# Design Review Board Agenda

**CITY OF MILL CREEK  
DESIGN REVIEW BOARD  
APPLICATION PL2016-0003**

**NAME OF PROJECT:** Harms Estate Preliminary Plat/Planned Area Development

**PROPOSAL:** Review of streetscape, common area, and roadway buffer landscaping.

L-1  
 SHEET 1 of 3

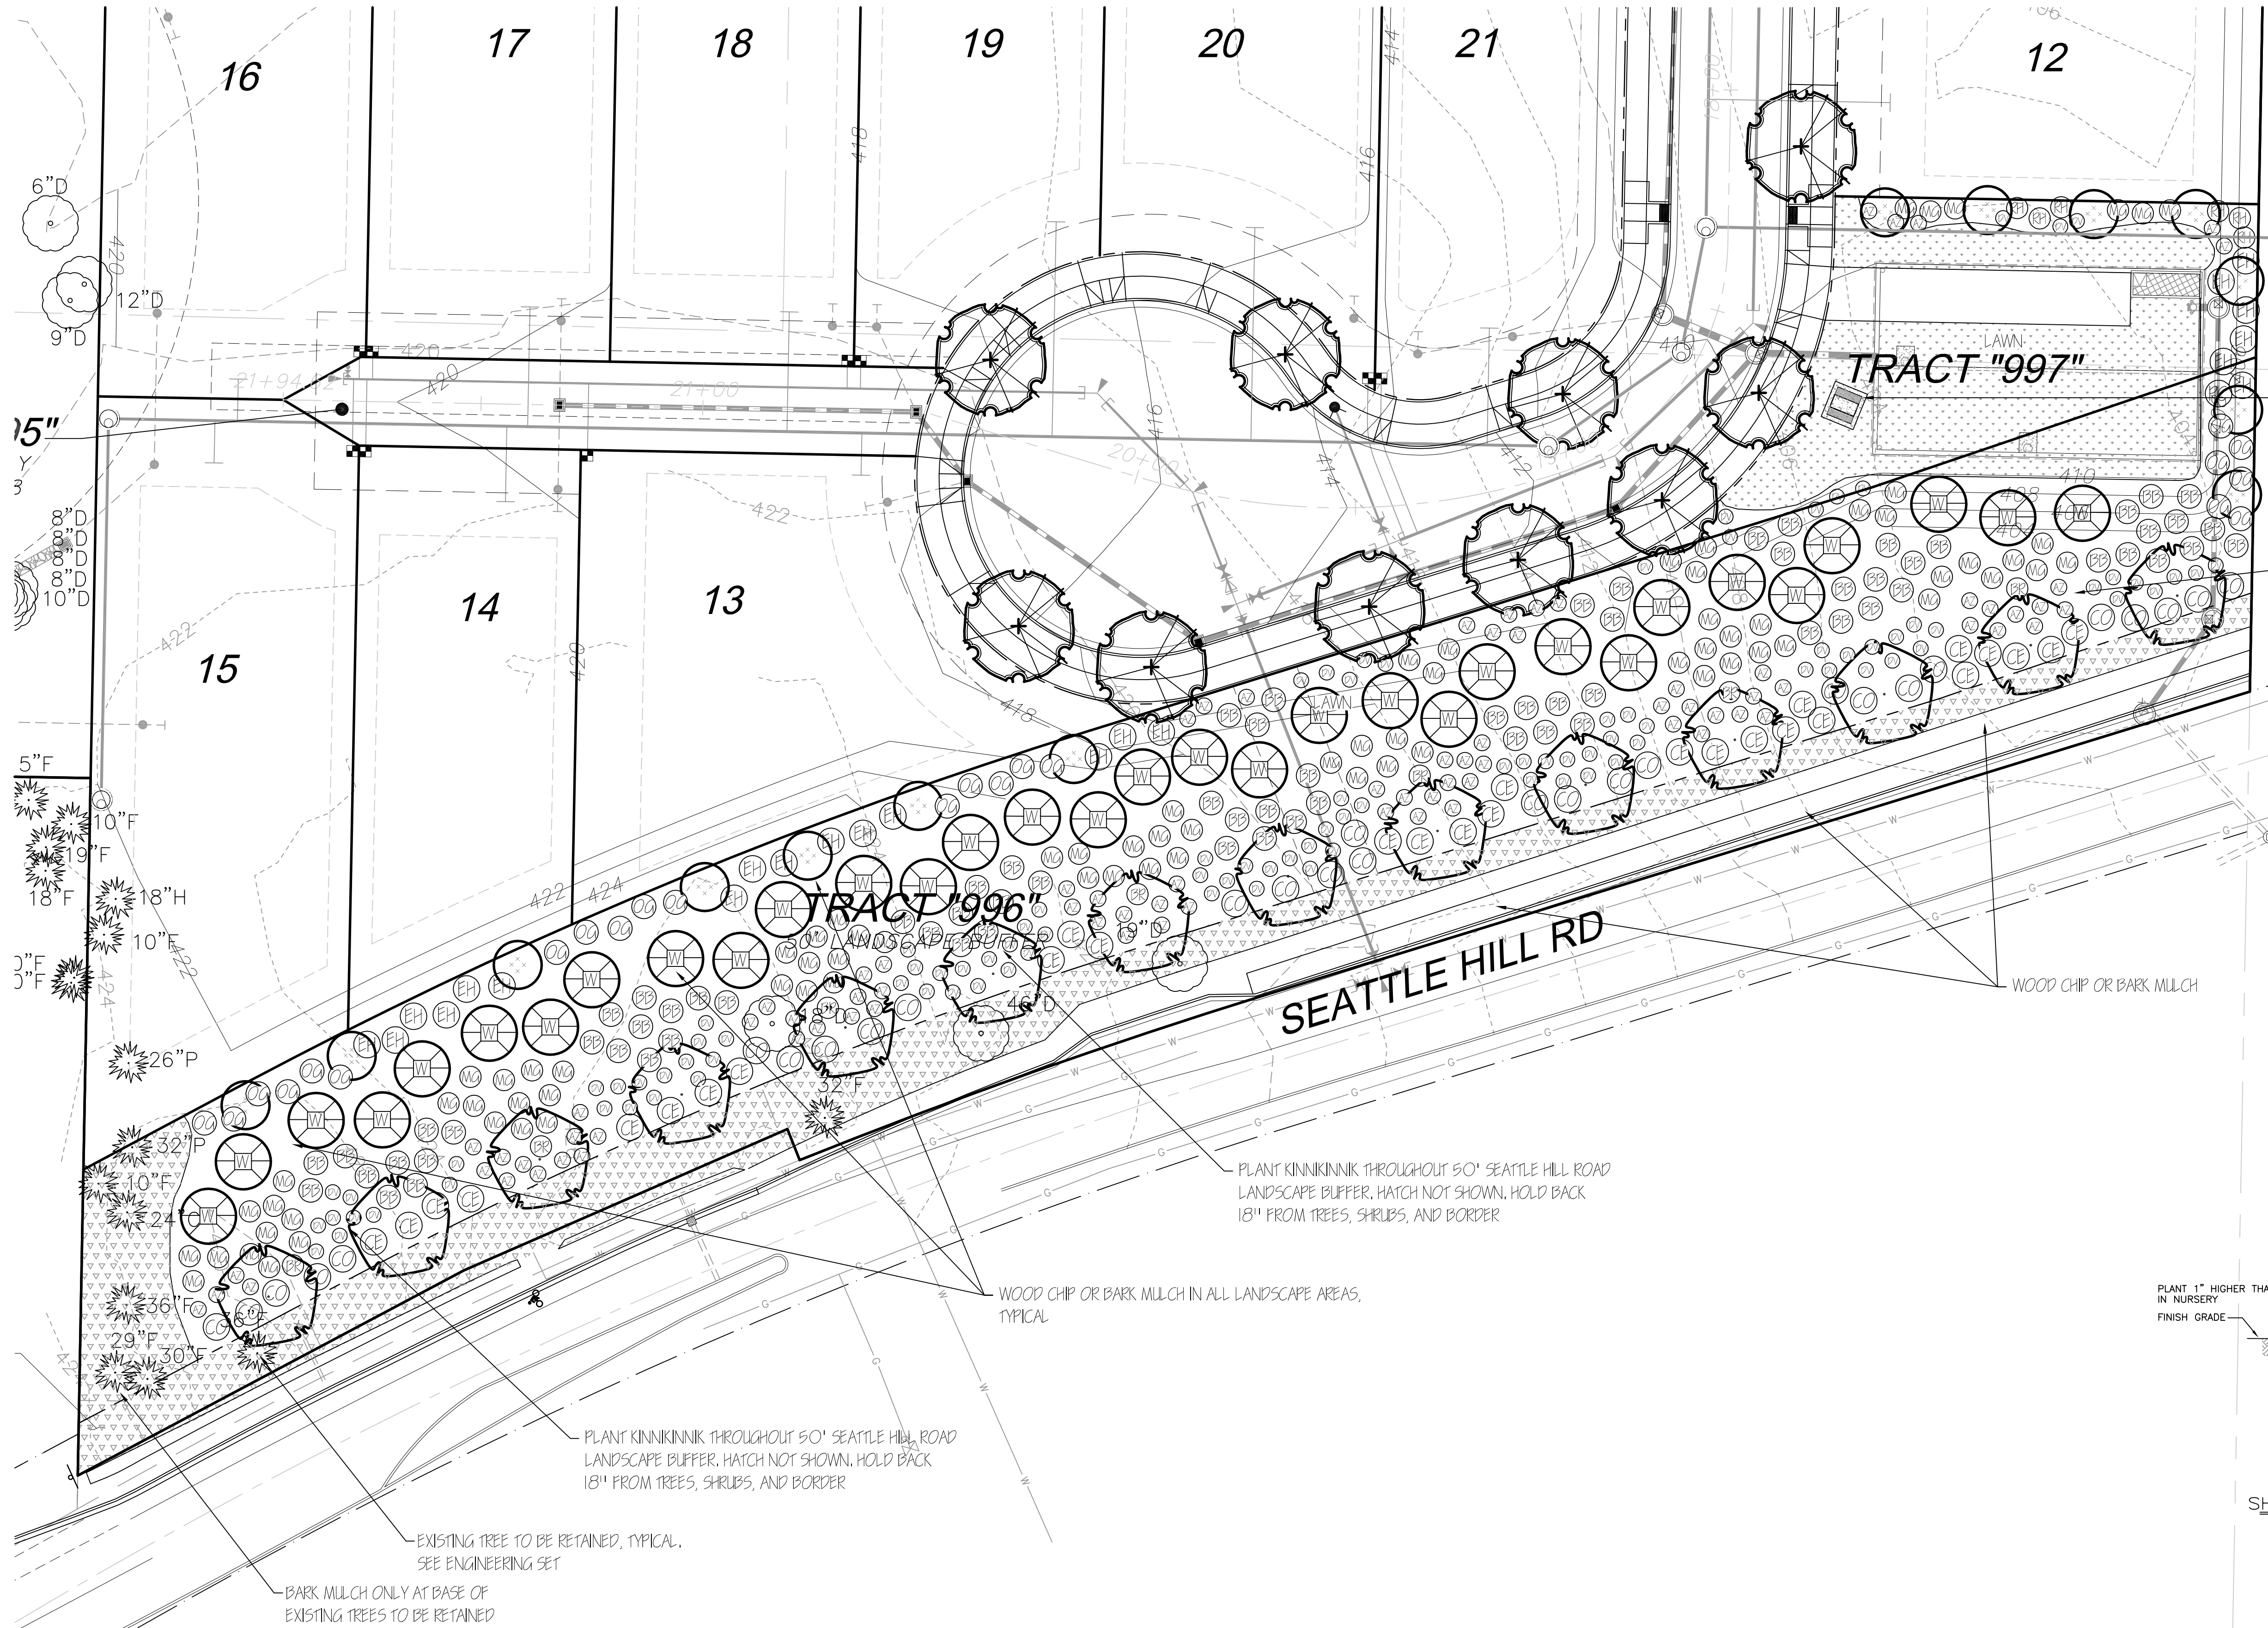
The applicant is proposing to use Red Maple as street trees, which will be planted in the five-foot wide landscape planter strip. The Red Maple is on the Approved Street Tree List. Per MCMC 17.34.040.H.1.c.i, street trees should be spaced 20 to 30 feet on center for a consistent streetscape appearance and to create a canopy. Staff has worked with the applicant to comply with the spacing requirement as much as feasible while avoiding conflicts with street lights, utility boxes/meters and driveways.

5. To reduce tree root growth under the pavement, a vertical root barrier treatment shall be installed in the five foot planting strip.

L-3  
SHEET 3 of 3

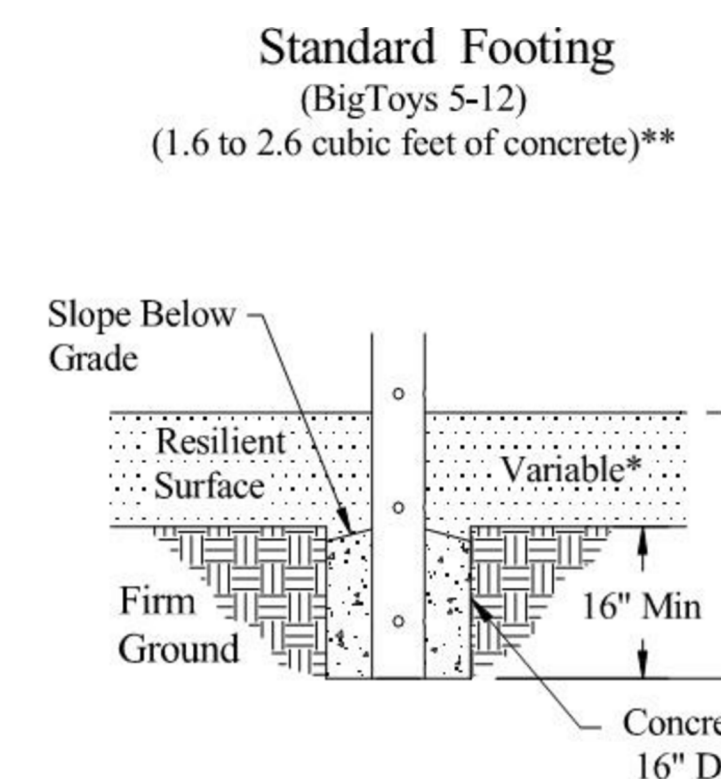
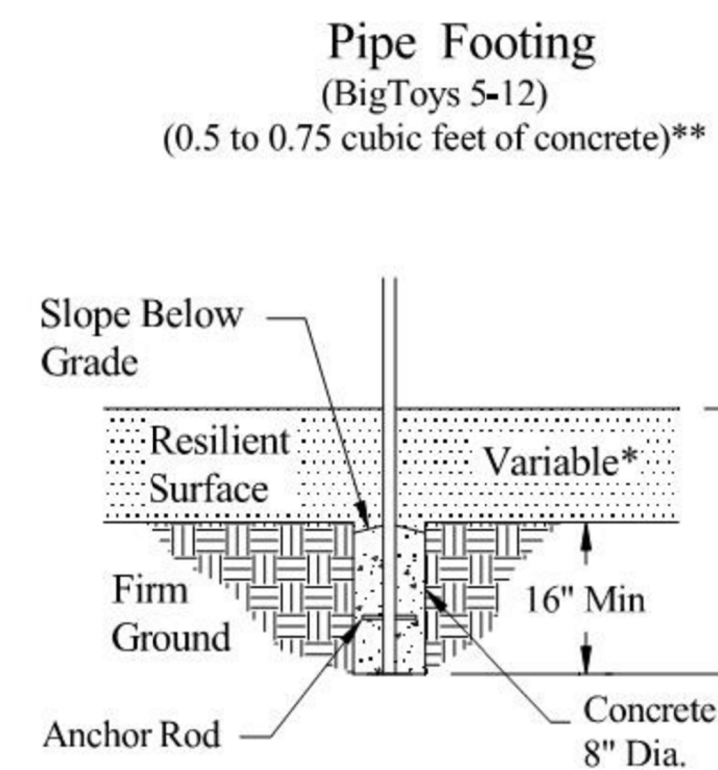
Per the conditions of the Preliminary Plat/Planned Area Development approval, the applicant has submitted a tree preservation plan and is making an effort to retain those trees and vegetation not specifically required for removal by utility installation, the installation of the public street, and the new homes. To supplement the preserved trees and vegetation, the applicant has selected primarily native plants. The trees to be preserved are shown on the landscape plan. *Sheet L-3* includes the landscape planting schedule with the complete plant listing.

The underground stormwater vaults are proposed to be located within common area/open space/stormwater Tracts 997 and 999. Per MCMC Section 17.34.040.A.4.c, underground vaults must have adequate soil cover to support the approved landscape plan. The soil must be of sufficient quality to properly support vegetation. Within the common areas, the applicant is proposing to include some benches and picnic tables, as well as a children's play structure, as recreational amenities for the future residents of the neighborhood.

3. Irrigation shall be provided for the roadway buffer and common area tracts (Tracts 997 and 999), per MCMC 17.34.040.H.1.d. The irrigation system will require a building permit. The permit is an over-the-counter plumbing permit, no plans required, with an inspection of the system's backflow prevention.

4. The underground vaults located within Tracts 997 and 999 shall have adequate soil cover to support the approved landscape plan. The soil shall be of sufficient quality to properly support vegetation.
